# **5 VOLT FlashFile™ MEMORY**

## **28F004S5, 28F008S5, 28F016S5 (x8)**

### **SPECIFICATION UPDATE**

Order Number: 297796-007

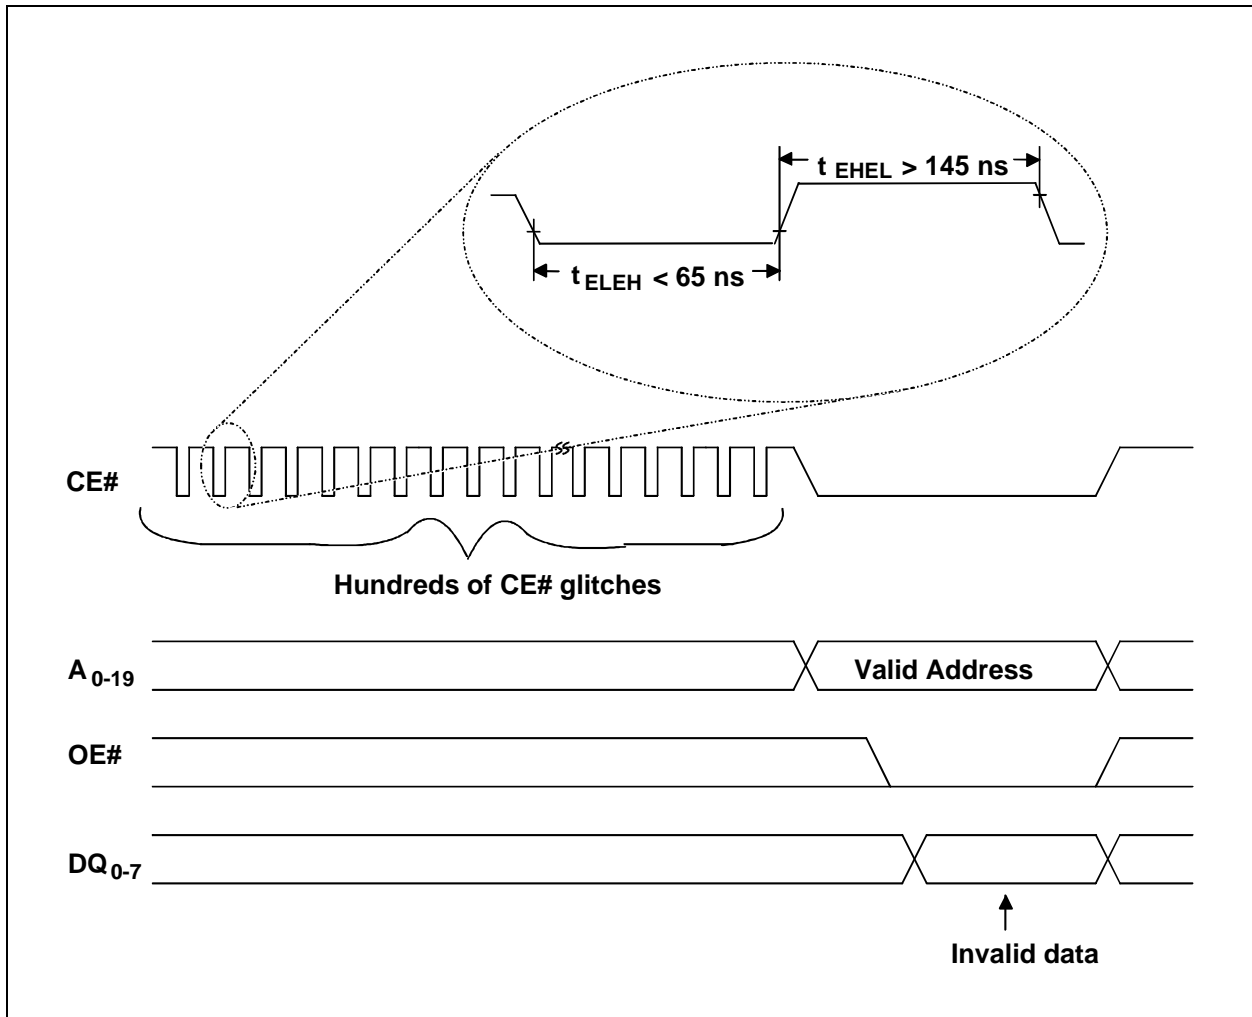
**PROBLEM:** For the 8- and 16-Mbit devices that are effected by this erratum, the block unlocking security feature is currently nonfunctional. Attempts to unlock blocks, using the clear block lock-bits command sequence, may cause subsequent program and/or block erase failures. The failure is seen as a device protection error in the status register.

**IMPLICATION:** Block unlocking feature is disabled. This erratum effects the following command, Clear Block Lock-Bits. Locking blocks using the Set Block Lock-bits command (while RP# is equal to 12 volts) is still supported.

**WORKAROUND:** To prevent accidental software block lock-bit clearing, Intel permanently sets the master lock-bit during the test flow. This disables the ability to lock and unlock blocks via software only with RP# =  $V_{IH}$ . Block locking and unlocking requires 12V on the component's RP# input when the master lock-bit is set. Don't execute the clear block lock-bits command sequence when 12V is applied to RP#. Instead, simply override the block locking mechanism by applying 12V to RP# to enable program/erase operations that target locked blocks.

If data security is of utmost importance, lower  $V_{PP}$  voltage equal to or less than  $V_{PPLK}$  during normal operations. With  $V_{PP}$  equal to or less  $V_{PPLK}$ , the device is protected against all data manipulation operations.

**A Long Series of CE# Glitches May Induce an Invalid Read**

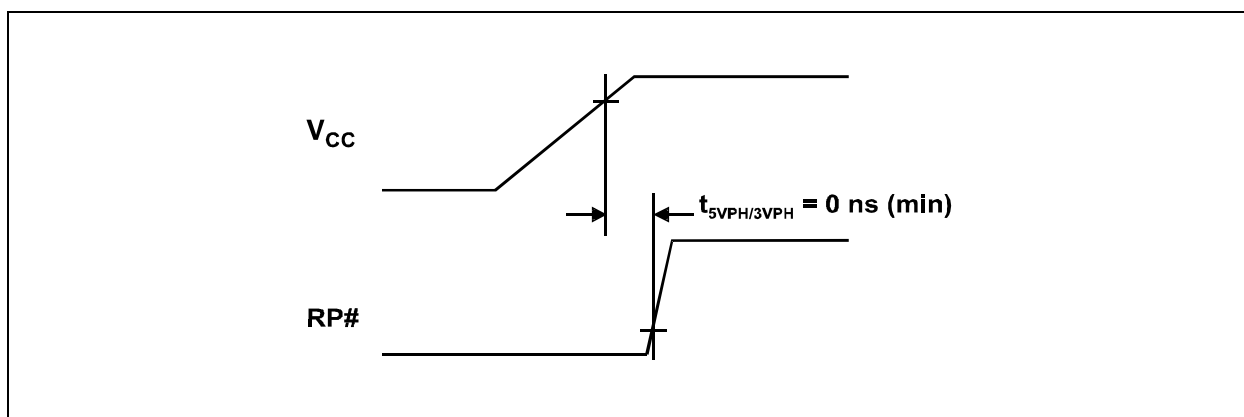
**PROBLEM:** A noisy CE# control signal may cause an invalid read. This erroneous read only occurs after the device has received over one hundred consecutive short CE# glitches ( $t_{EHL} < 65 \text{ ns}$ ) with CE#-high time ( $t_{EHEL}$ ) greater than 145 ns (see the figure below, *A Long Series of CE# Glitches May Induce an Invalid Read*).

After valid data is read, the device must receive another series of CE# glitches (typically over one hundred) to induce an invalid read.

**WORKAROUND:** If it is determined that the CE# causes a problem, possible solutions to help workaround this erratum are suggested as follows.

Add system logic to prevent CE# glitches such as latched CE# control logic or pullup/pulldown resistors to the address bus.

If the device receives over one hundred consecutive CE# glitches, issue a Byte Write command and program FFh to any location before executing a read operation. Programming FFh will not alter stored data, but it will give the component sufficient time to prepare for the read operation.
